PREPARED FOR THE URBAN DESIGN COMMISSION AND PLAN COMMISSION

Project Address: 330 East Wilson Street
Application Type: Demolition Permit and Conditional Use
Legistar File ID #: [33909](#)
Prepared By: Heather Stouder, AICP, Planning Division
Report Includes Comments from other City Agencies, as noted

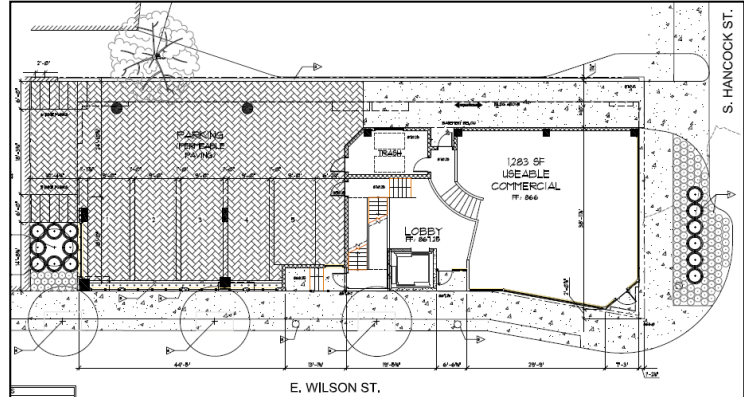
The revised proposal accommodates a similar program within a similar building as was discussed in the staff report dated June 11, 2014 and subsequently the addendum dated July 28, both of which are included for reference. Notably, the under-building parking area has been modified to allow space for a small commercial space along the western half of the building, instead of the shallow display area that had been proposed as a screen for the parking area behind it. This change addresses a major staff concern, and allows for the removal of Condition No. 1 from the June 11 staff report.

The revised site plan now includes four parking stalls instead of five, and an additional 645 square foot commercial space, complete with a detailed floor plan showing an office layout. The applicant has indicated that this space will be utilized for their office space, and while it may only be viable as an office space for small businesses or non-profit organizations over time, zoning would allow for it to be utilized for a variety of uses.

October 6 Submittal UDC/PC Submittal

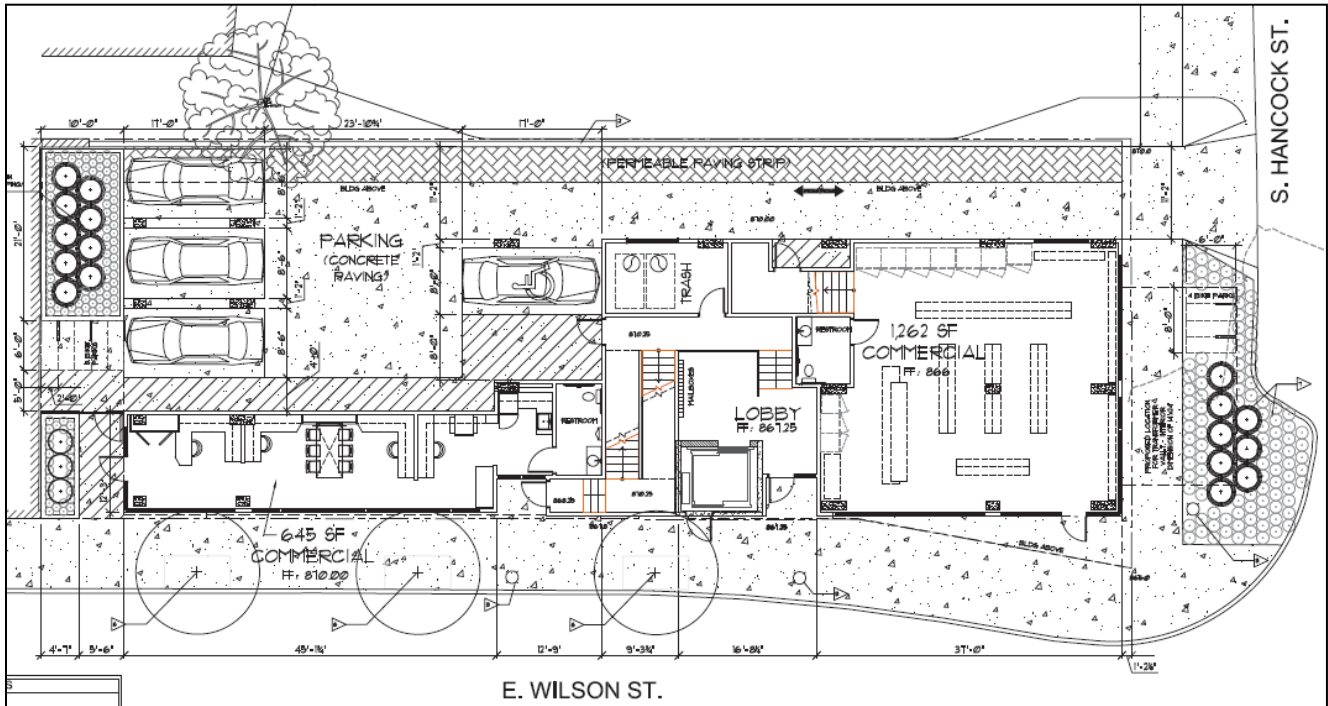
Stair tower revisions – In the October 6 revisions, the stair tower is now a grey stone, and includes an inset panel of cedar lap siding proposed to be painted in various shades of blue. The metal and a set of windows overlap the tower element in the area of the stairway, replacing what had been vertical glass within the stone tower element itself. The top of the stair tower is wider along East Wilson Street, and while the vestibule leading from the tower to the outdoor open space on the rooftop is smaller, revisions to this area still need to be made to meet Zoning requirements. The UDC has discussed the stair tower in each meeting where this project has been reviewed, and staff looks forward to further input from the UDC on this significant architectural piece.

Building color – The proposed color of the metal panels is now a very light grey, rather than white, and it has inset areas with blue fiber cement ship lap siding on all sides of the building. Staff maintains that a contemporary brick building would be preferable in this location (see Analysis section). However, if it is approved as a metal building, staff would like UDC feedback on the proposed color scheme.
